SAHORI SUBDIVISION

The plat illustrates the proposed 1 lot, 1.1 ± acre subdivision located on the Northwest corner of Toulmin Avenue and St. Stephens Road extending to the Southwest corner of St. Stephens Road and Seal Street, and is located in Council District 1. The applicant states that the subdivision is served by both public water and sanitary sewer.

The purpose of this application is to create one legal lot or record from 4 existing legal lots.

DETAIL SITE PLAN

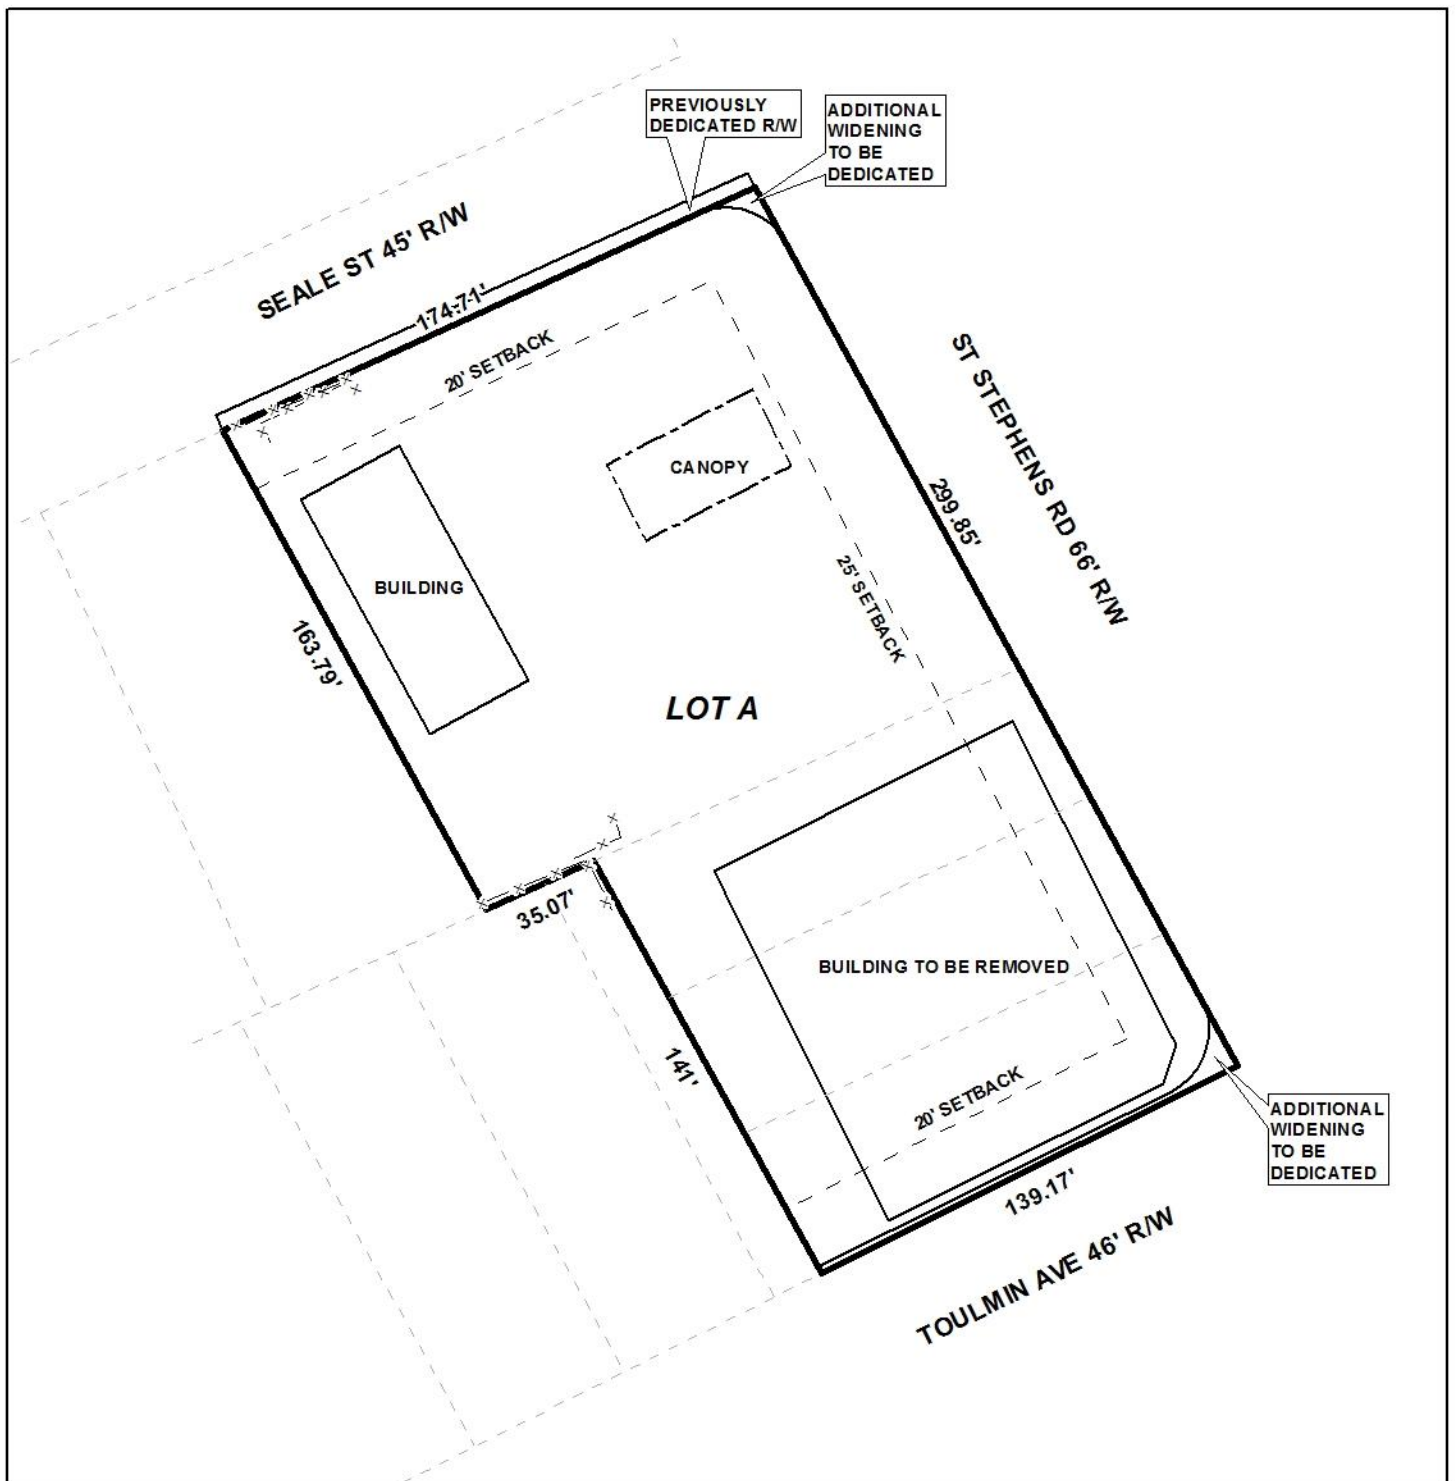
The site fronts Toulmin Avenue and Seale Street, both minor streets with curb-and gutter. The preliminary plat depicts Seal Street as having a 45' right-of-way with a note on the plat stating "Previously dedicated R/W" with an additional 5' displayed. The plat depicts Toulmin Avenue as has having a 45' right-of-way with a note stating "additional widening to be dedicated". Dedication to provide 25' as measured from centerline from Toulmin Avenue will be required. The site also has frontage on St. Stephens Road, a major street as illustrated on the Major Street Plan. Per the Major Street Plan, St. Stephens Road will utilize the existing right-of-way, thus no dedication is required.

The site is currently developed with a gas station and a vacant building which is illustrated as being removed. The site has 4 existing curb-cuts and what appears to be a large ribbon curb. If approved, a note should be placed on the Final Plat stating the proposed lot is limited to two curb-cuts to St. Stephens Road, to be approved by ALDOT and Traffic Engineering; and one curb-cut each to Toulmin Avenue and Seal Street with the size, design and location be approved by Traffic Engineering and conform to AASHTO standards.

The lot size is not labeled in square feet and acres. If approved, revisions should be made to the Final Plat to depict the lot size in square feet and acres, to include dedication.

The 25' minimum building setback line is depicted on the plat. Any additional dedication required along Seale Street and Toulmin Avenue will also require revisions to the setback lines.

A corner radius in compliance with Section V.D.6. of the Subdivision Regulations is depicted on the preliminary plat with a note stating "additional widening to be dedicated". Changes due to dedication will require revision to the Final Plat.

- 1) dedication sufficient to provide 25' from the centerline of Toulmin Avenue;
- 2) revision of the minimum building setback lines to reflect dedication;

- 3) revision of the plat to depict the lot size in square feet and acres;
- 4) revision of the lot size in square feet and acres to reflect dedication;

- 5) placement of a note on the Final Plat stating the lot is limited to two curb-cuts to St. Stephens Road, to be approved by ALDOT and Traffic Engineering; and one curb-cut each to Toulmin Avenue and Seal Street with the size, design and location be approved by Traffic Engineering and conform to AASHTO standards;
